Service Bulletin No. GS20071003
Subject: Fuel Cap Replacement
Models: GA25H, GA29R and GAW135H
Product Group: Generator/Welder-Generator
Date: October 03, 2007

SERVICE BULLETIN

Figure 1. Fuel Cap Removal

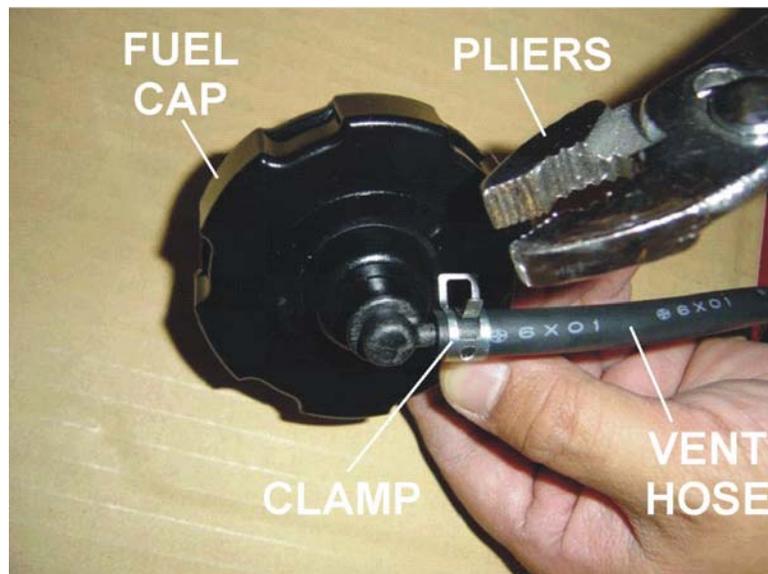
<p>SERVICE INFORMATION</p> <p>MANDATORY UPDATE: FAILURE TO FOLLOW INSTRUCTIONS MAY LEAD TO INJURY OR DEATH AND CAUSE SEVERE UNIT DAMAGE!</p> <p>Problem:</p> <ul style="list-style-type: none"> • Multiquip has become aware that the fuel cap has insufficient venting. • Fuel may erupt when the fuel cap is removed. This condition <i>may lead to injury or death and severe unit damage!</i> <p>Solution: Replace existing fuel cap with new fuel cap (blue dot on underside of cap).</p> <p>Action Required: See following pages for removal and replacement of fuel cap.</p>
--

1. Remove the existing fuel cap (twist-off) from fuel tank.
2. Next, using pliers, grip and squeeze the tabs on the retaining clamp (Figure 1) and slide clamp backwards on the vent hose away from the fuel cap. Pull off the vent hose removing it from the fuel cap vent inlet.
